# CORRECTIVE ACTION PLAN MODIFICATION FORMER DUPONT KENTEC FACILITY

Date: October 2005

Revision 1

RE: Corrective Action Plan Modification, Response to Comments  
Former DuPont Kentec Facility  
Kinston, Lenoir County, NC  
APS Incident 6334

CREATED BY: ND	DUPONT PROJECT NO.: 4427
DATE: 10/10/05	URSD PROJECT NO.: 18324333
REVISION:	FIGURE NO.: 2
FILE NAME: G:\Kentec\Gis\Project_figures\CAP-MOD\Ken_Site_Layout.mxd

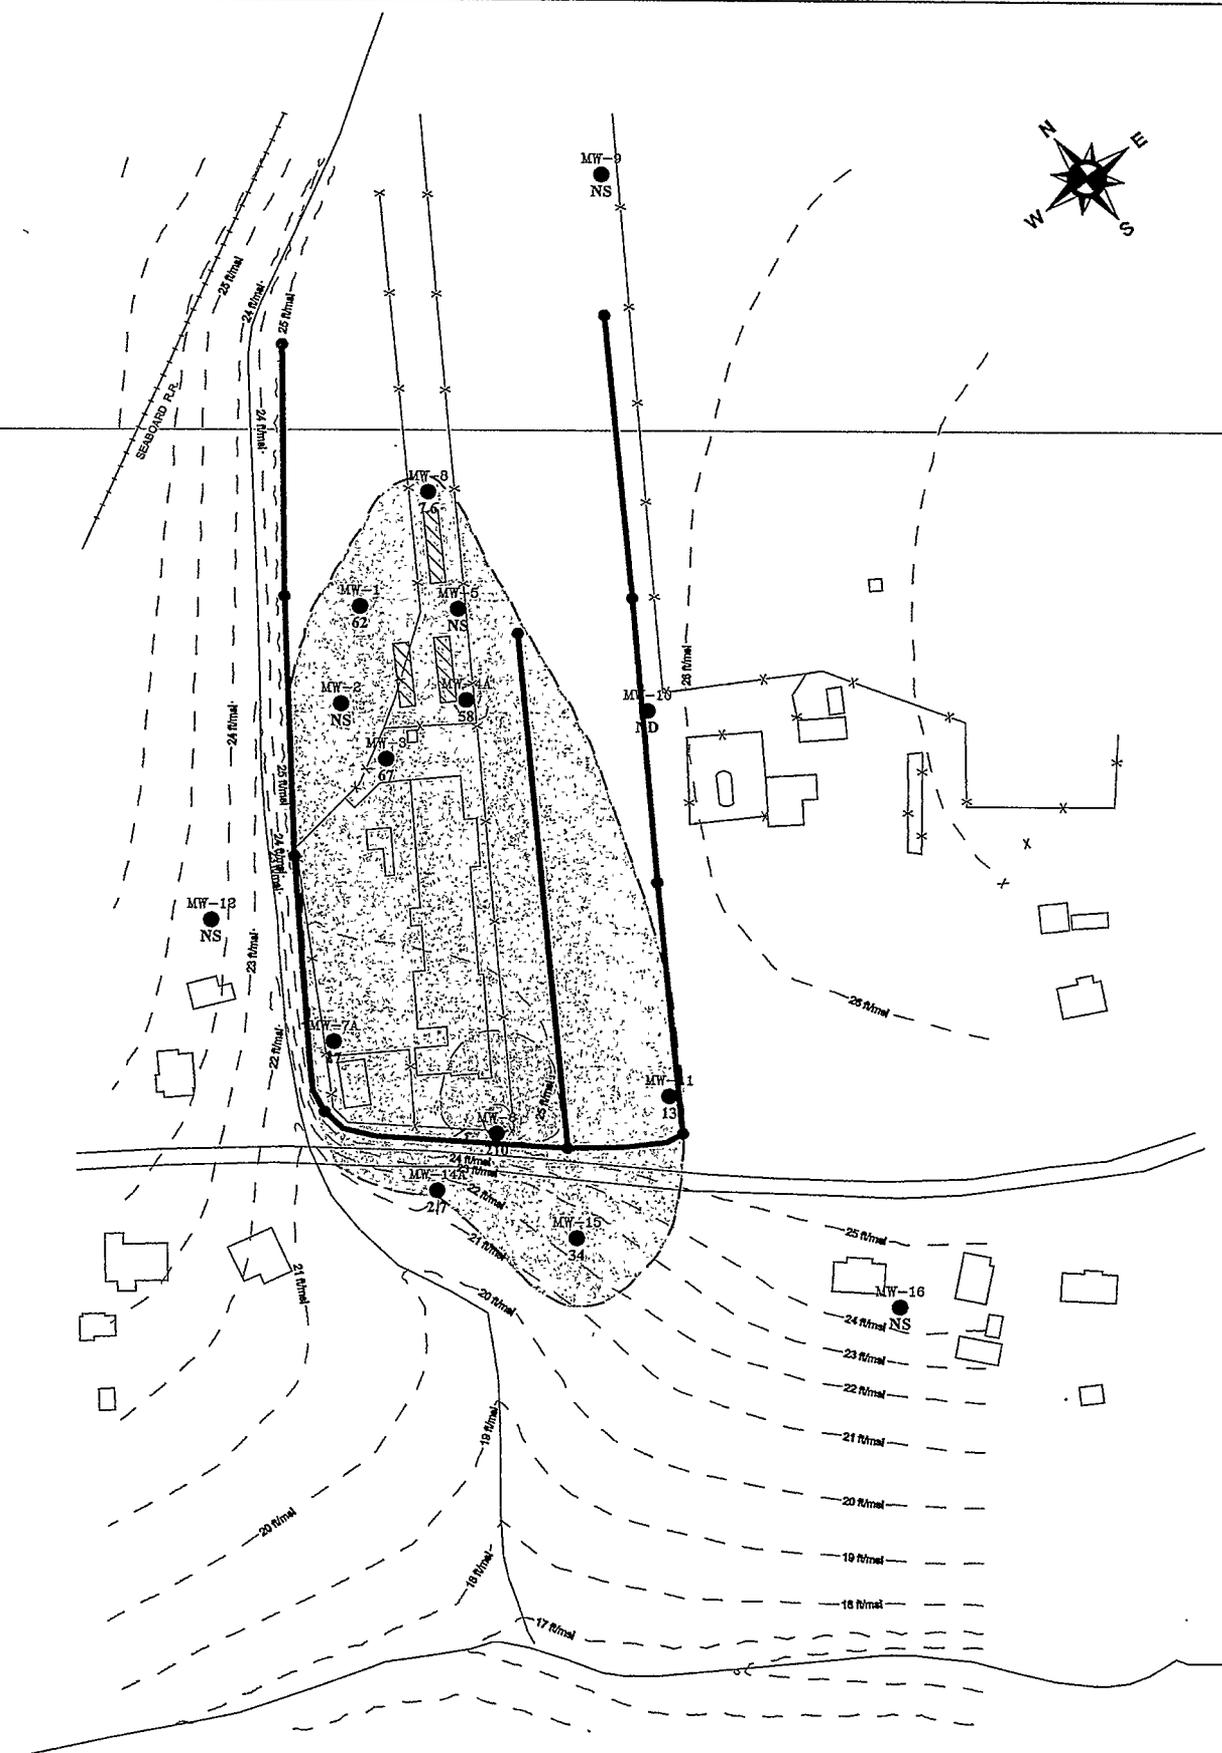
12. Figure 2 has been modified to include these wells.

Figure 9. Concentration Trends - MW-11A (1,4-Dioxane)

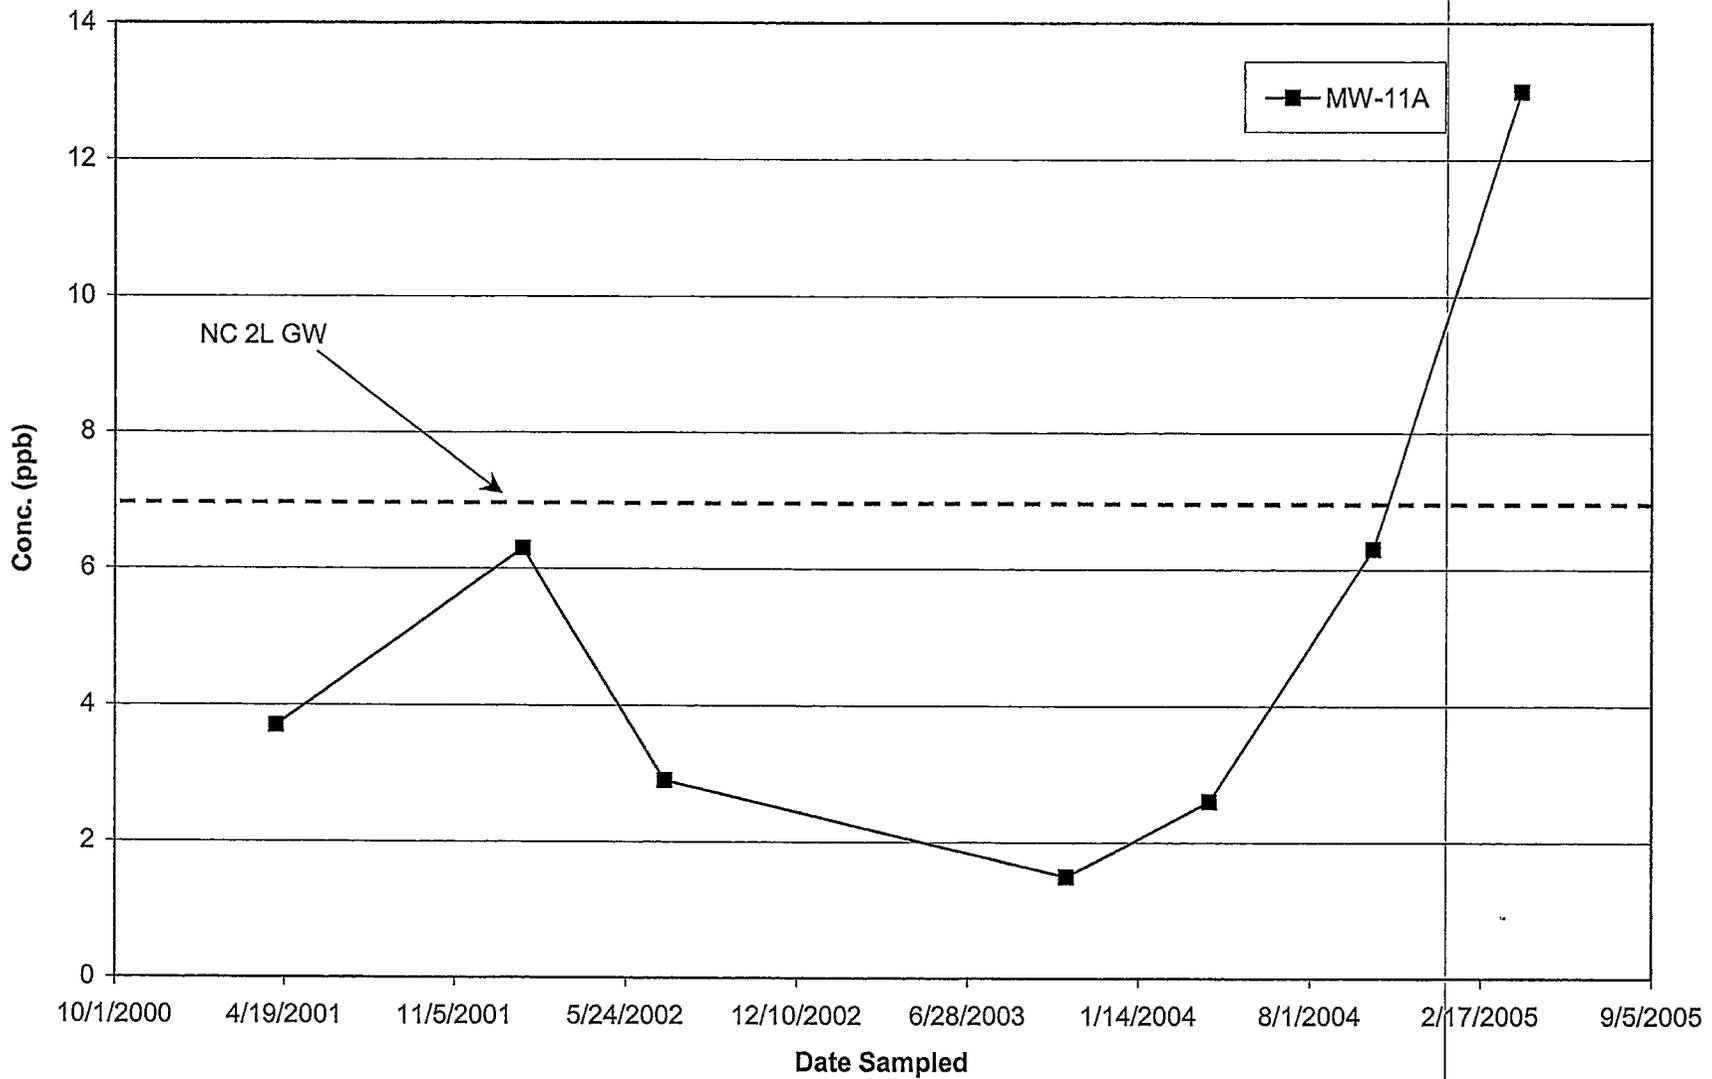
7. This statement has been modified to exclude Figure 9 (MW-11A).
  8. MW-9 currently is not monitored on a routine basis, for the purpose of natural attenuation monitoring MW-9 will be added to the routinely monitored wells in place of MW-8; therefore, it was added to the section titled "*Additional Routine Monitoring*".

CREATED: ND	DUPONT PROJECT NO.: 4427
DATE: 10/10/05	URSD PROJECT NO.: 18994393
REVISION:	FIGURE NO.: 13
FILE NAME: G:\Kentec\GIS\Project_figures\Ken_Natural_Atten\attenuation_Loc.mxd

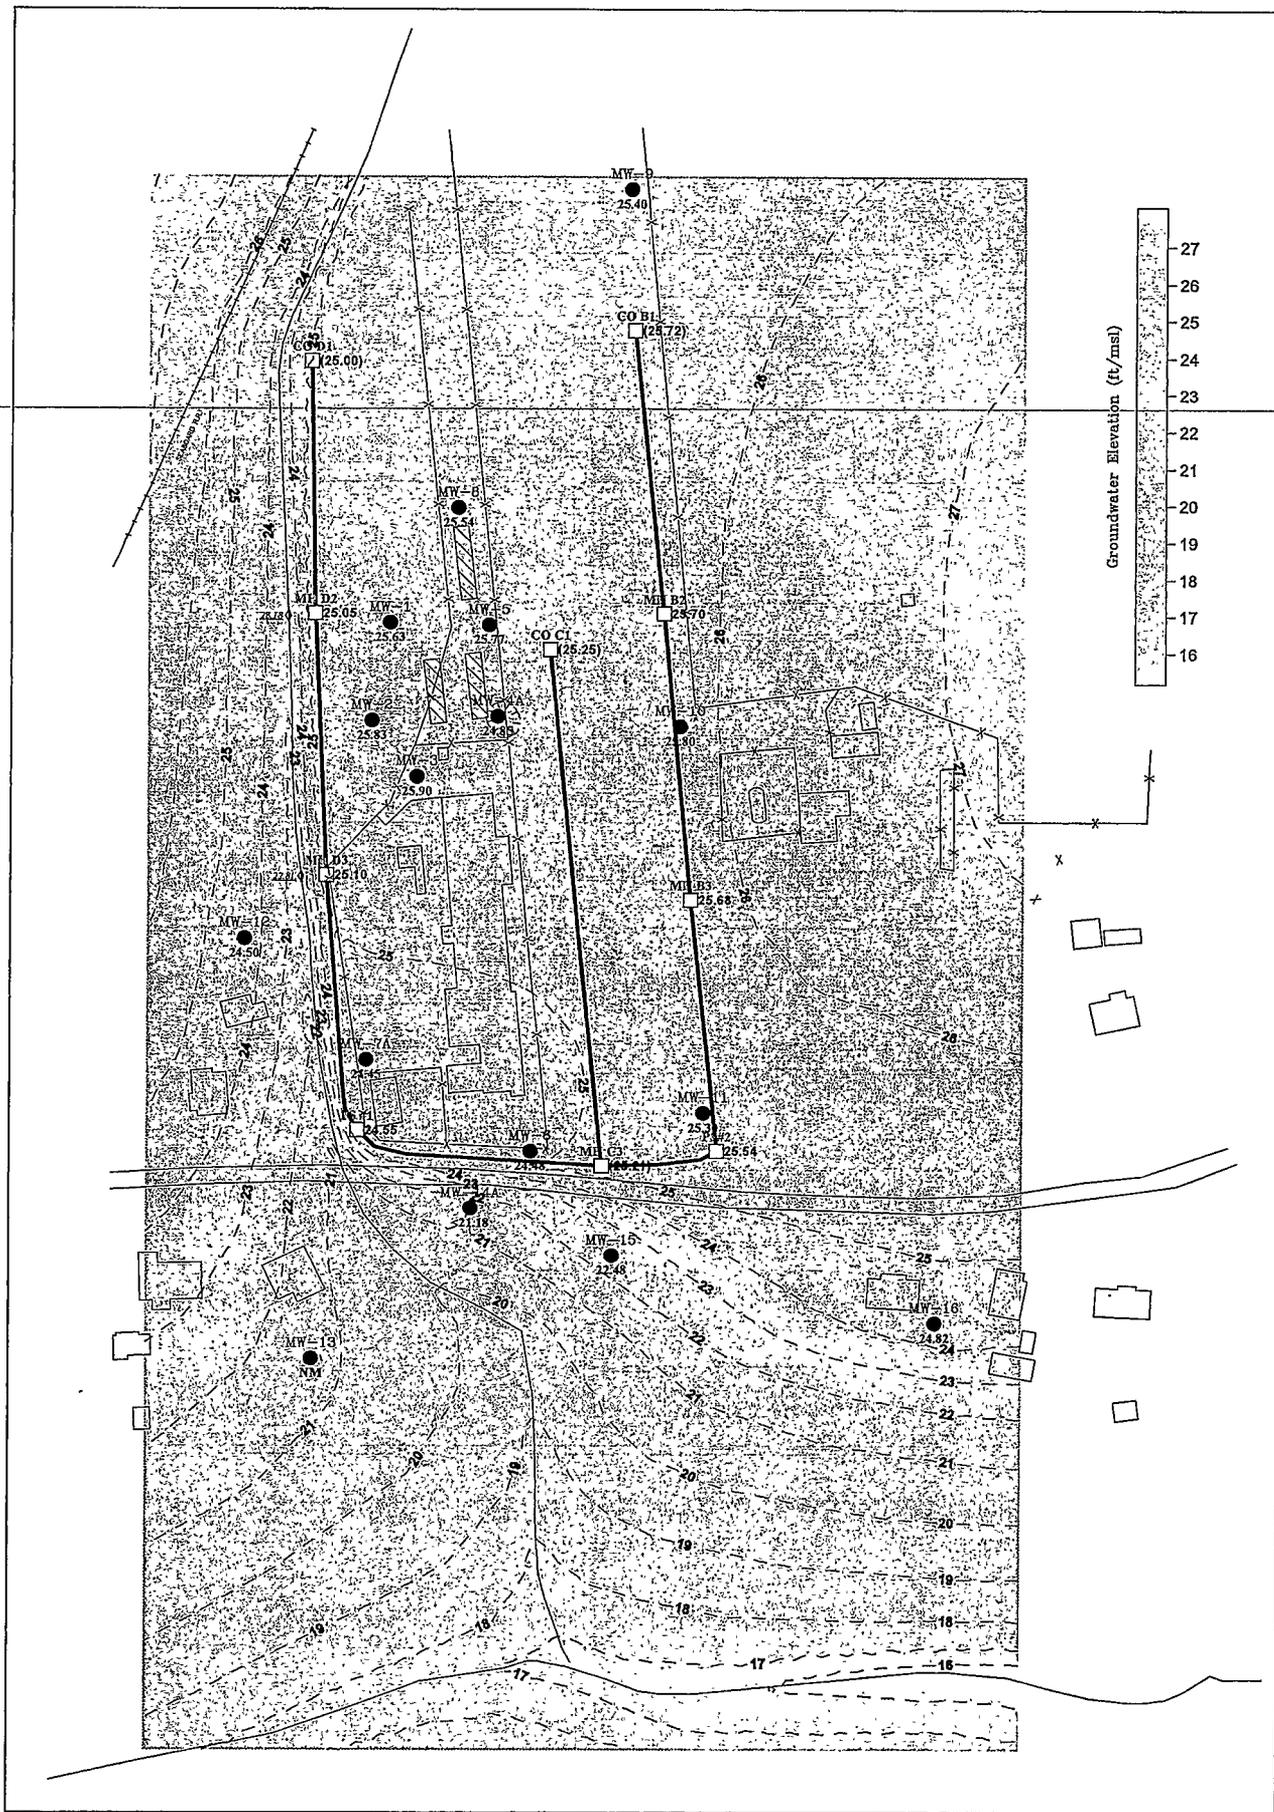
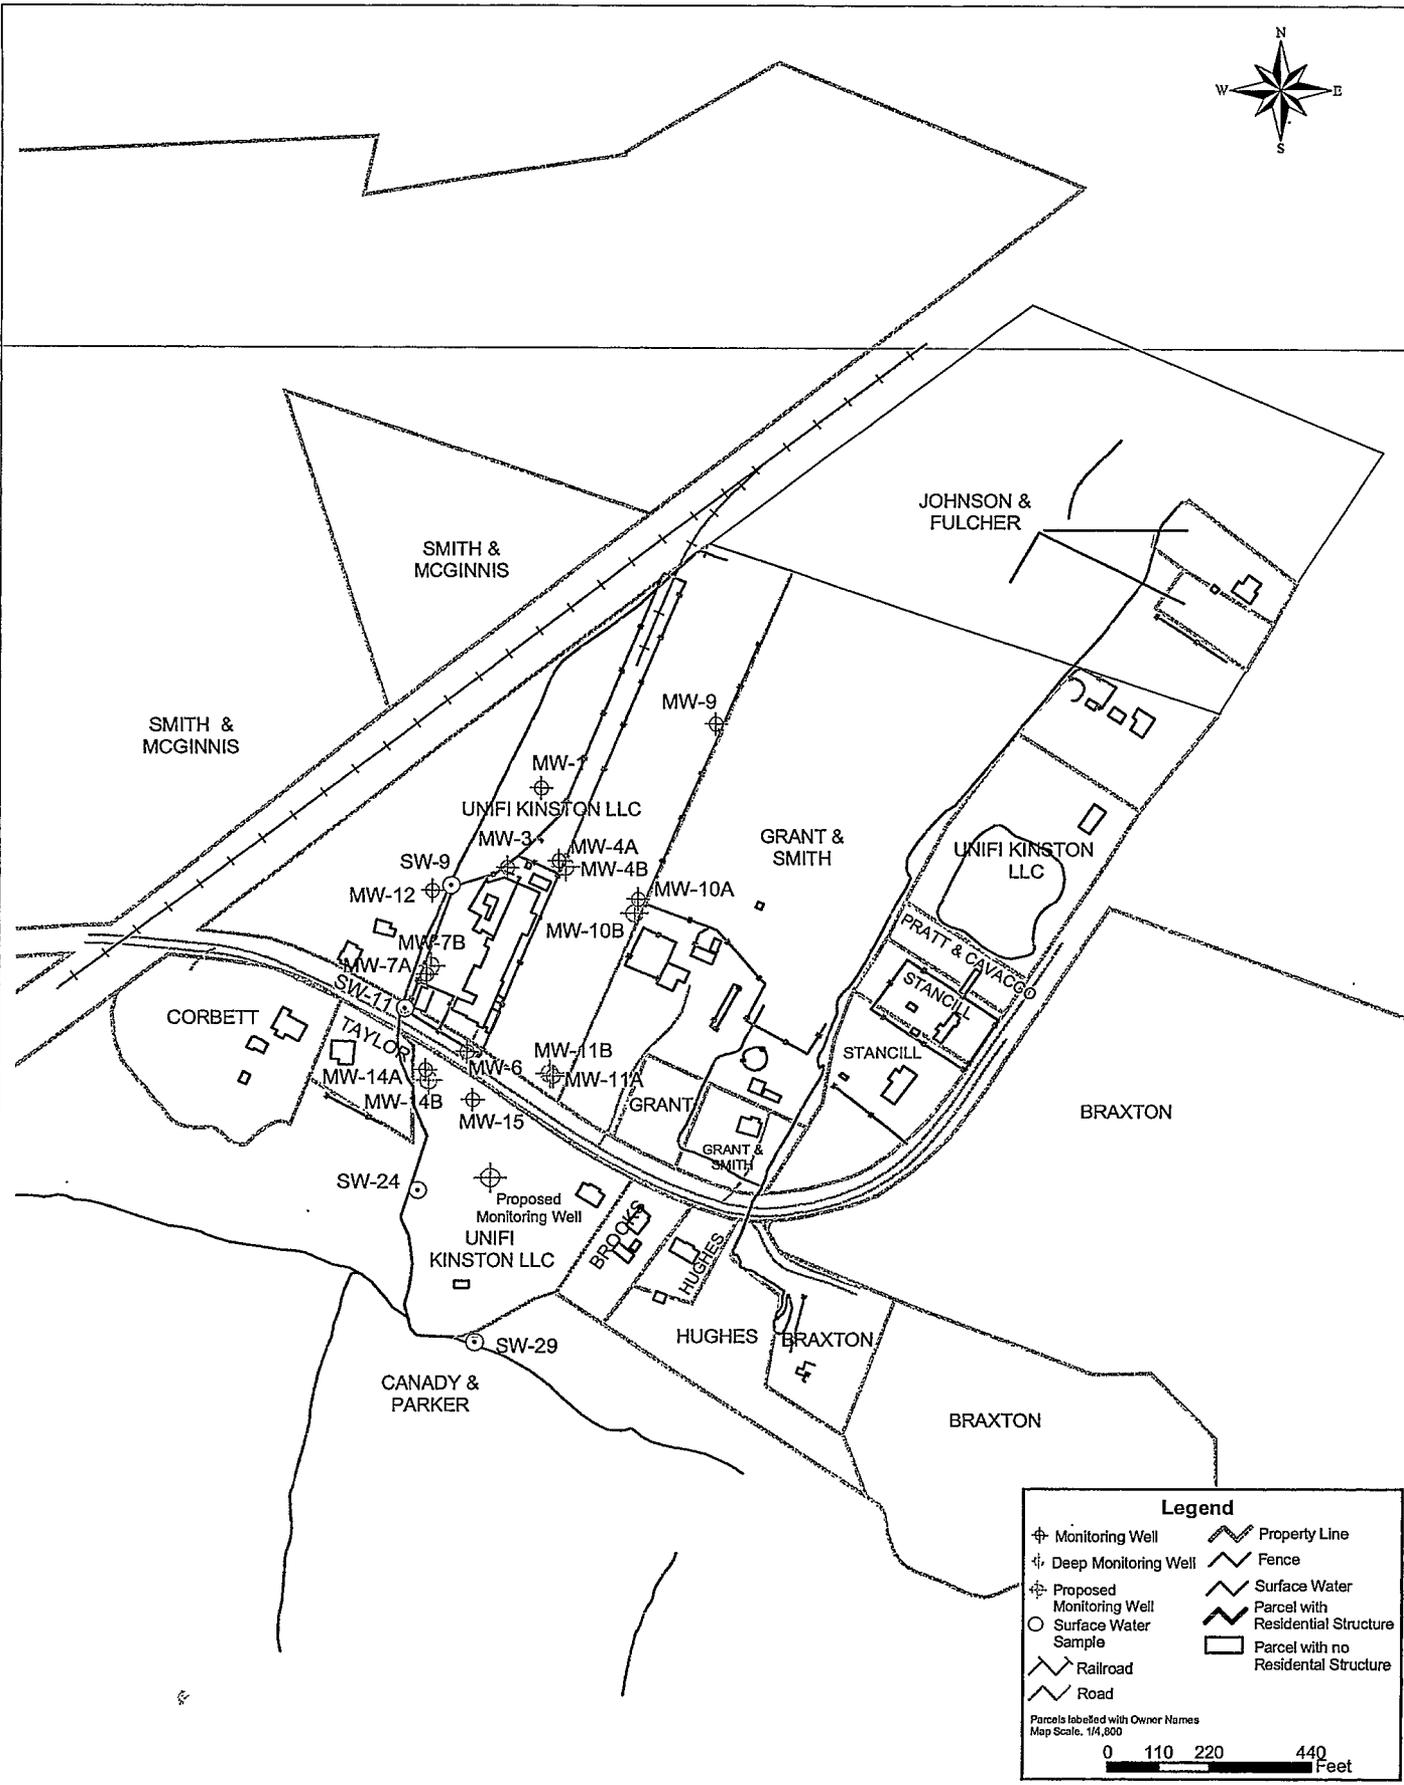
13. Figure 13 has been modified to include these wells.
